SCHEMATIC REVIEW - APPROVED

RE: QUIZNOS SUB
"Ellen" Store
807 Canal St.
New Orleans, LA
(Accepted 02-24-06)

1ST FLOOR
ELLEN'S STORE
807 CANAL ST.
2312 TOTAL S.F.

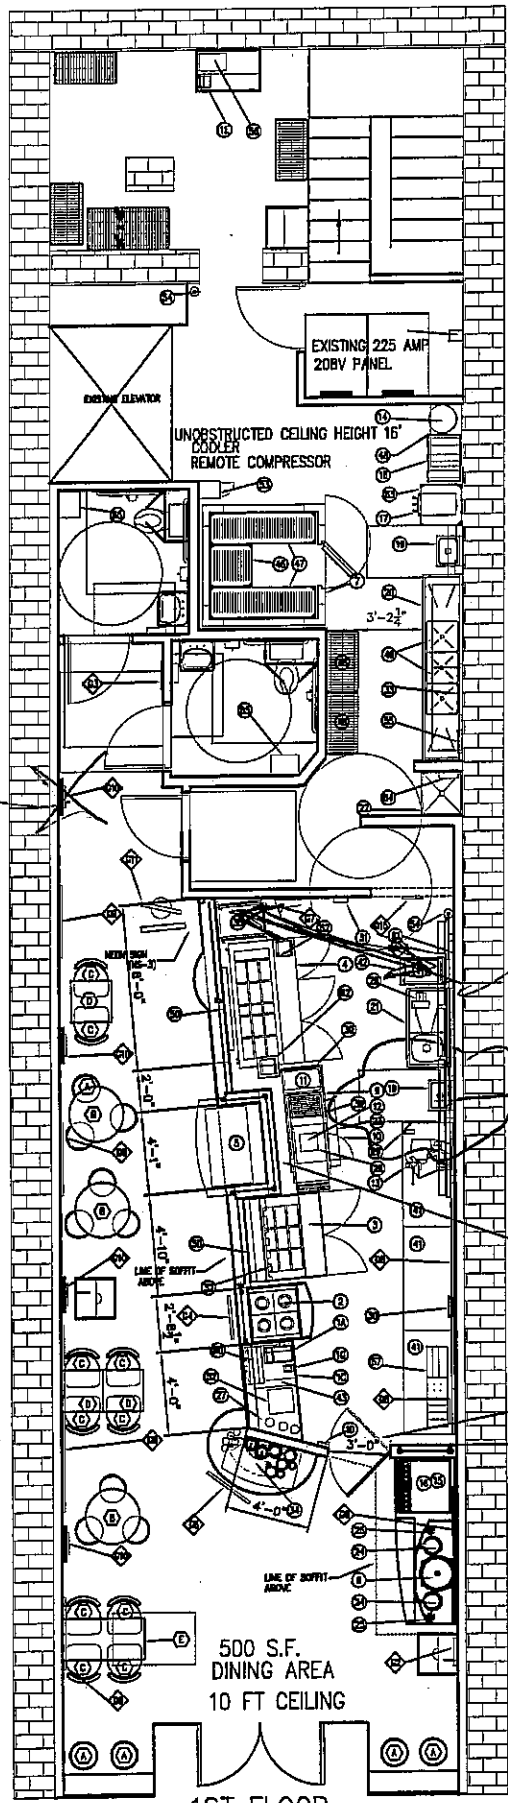
Relocate toaster
in hallway

Show Ind warmer
& cart adjacent to
boiler for dust order

Relocate

Verify build-out
square footage

Verify 10' finished
ceiling height

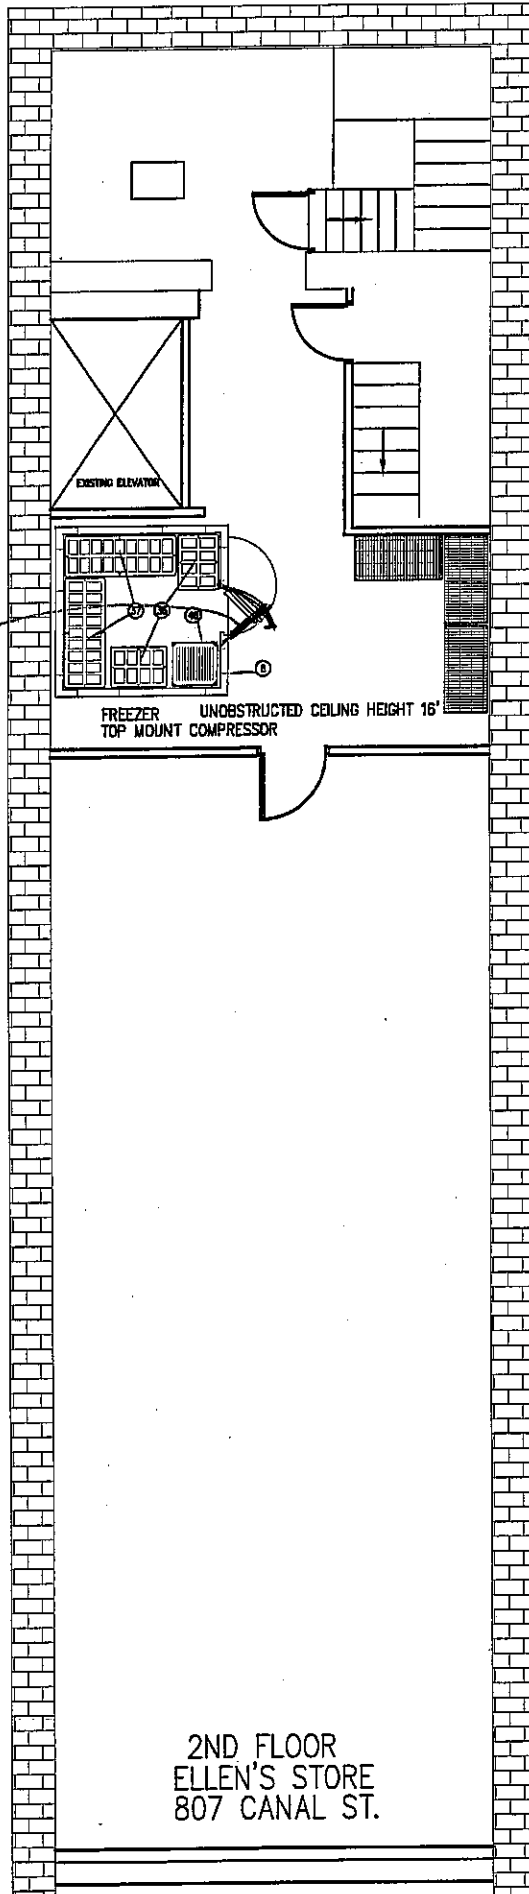
*Reverse door
swing*
